SUBJECT: **Safety Recall 07S48: Supplement #2**
Certain 2003 through 2005 Model Year Crown Victoria Police Interceptor (CVPI)
Vehicles - 16" Steel Wheel Replacement

New! REASON FOR SUPPLEMENT #2

Safety Recall 07S48 – Supplement #2
Certain 2003 through 2005 Model Year Crown Victoria Police Interceptor (CVPI) Vehicles
16" Steel Wheel Replacement

**SERVICE WHEEL WITH STICKER ATTACHED AS SHOWN
 DO NOT REMOVE STICKER**

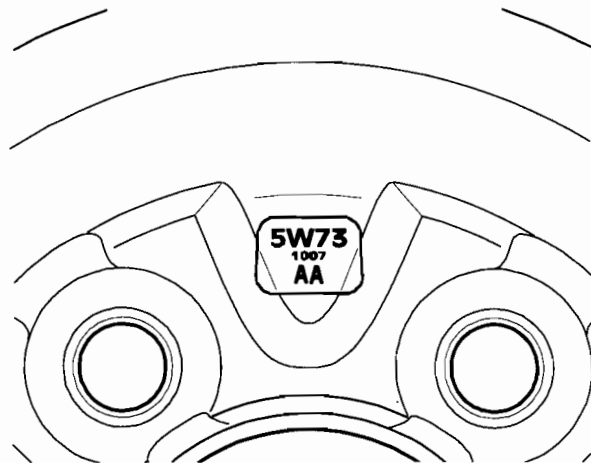
****NOTE:** A very small number of these service wheels will have a sticker identifying the service part number. Most service wheels will have the part number stamped on the wheel. See illustration below.

FIGURE 1

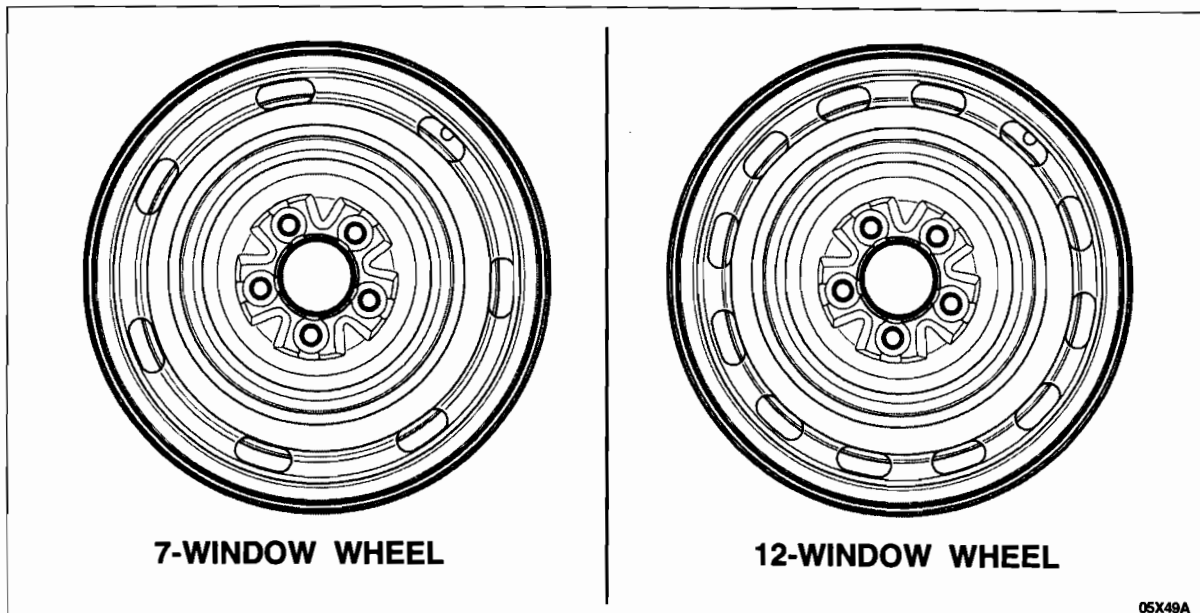
All replacement wheels will be of the 12-window configuration. See Figure 1.

FIGURE 2

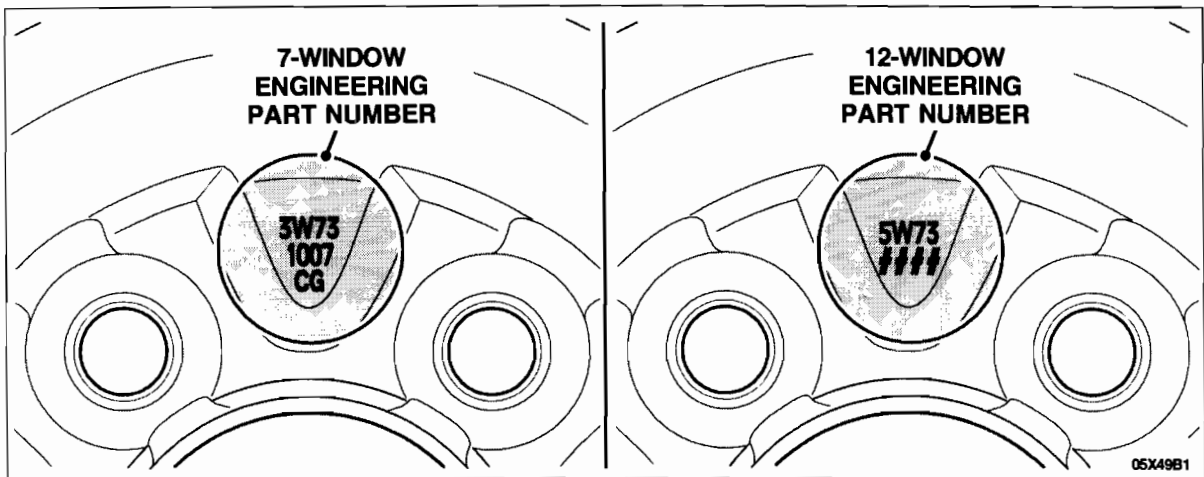
Inspect the engineering part number on all wheels including the spare. See Figure 2.

SERVICE ACTION		
IF 7-WINDOW WHEELS ARE ON THE VEHICLE		
Is the part number stamped on ALL the 7-window wheels 3W73-1007-CG?	YES	Vehicle not eligible for new wheels. Advise the customer the vehicle is already equipped with the latest level wheels.
	NO	All wheels on vehicle are eligible for replacement using new 12-window wheels – Order SPN - 5W7Z-1007-AA. (a)
IF 12-WINDOW WHEELS ARE ON THE VEHICLE		
Is the part number prefix stamped on ALL the 12-window wheels 5W73?	YES	Vehicle not eligible for new wheels. Advise the customer the vehicle is already equipped with the latest level wheels.
	NO	Only wheels <u>not</u> stamped with 5W73 part number prefix are eligible for replacement using new 12-window wheels – Order SPN - 5W7Z-1007-AA. (a)
SPARE WHEEL		
All suspect 7- and 12-window SPARE wheels will be replaced with new design 12-window wheels (SPN# 5W7Z-1007-AA) regardless of whether the 4 installed road wheels are of the 7- or 12-window design.

FIGURE 3

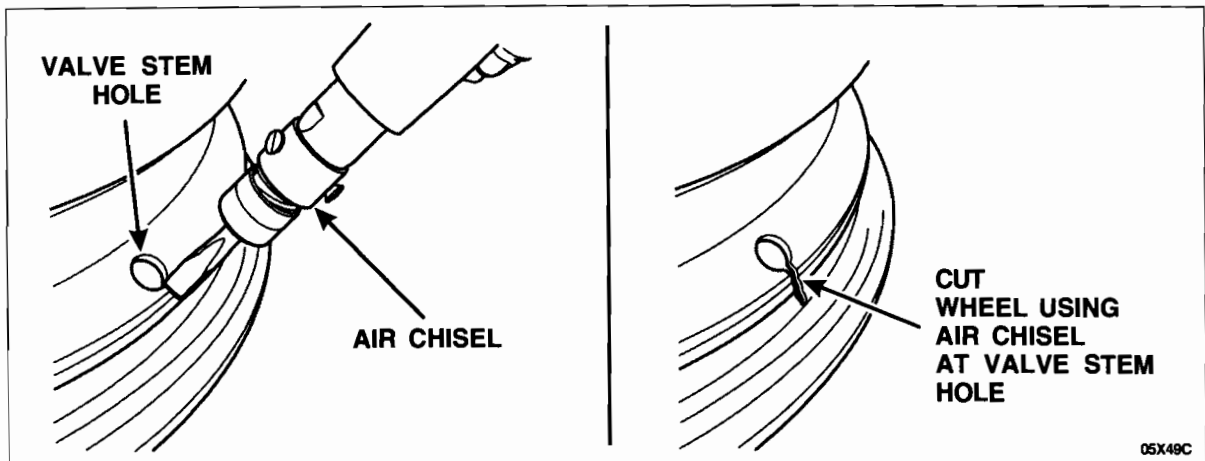
1. With the wheel facing down, use an air chisel with a sharp bit to cut a gouge no less than 12 mm (1/2 inch) long in the wheel from the valve stem hole down toward the bead area. The gouge must be large enough and the wheel deformed enough to make sure it cannot be easily repaired. See Figure 3.
2. Retain the wheel for possible warranty parts return. See your service manager or parts manager for further instruction.
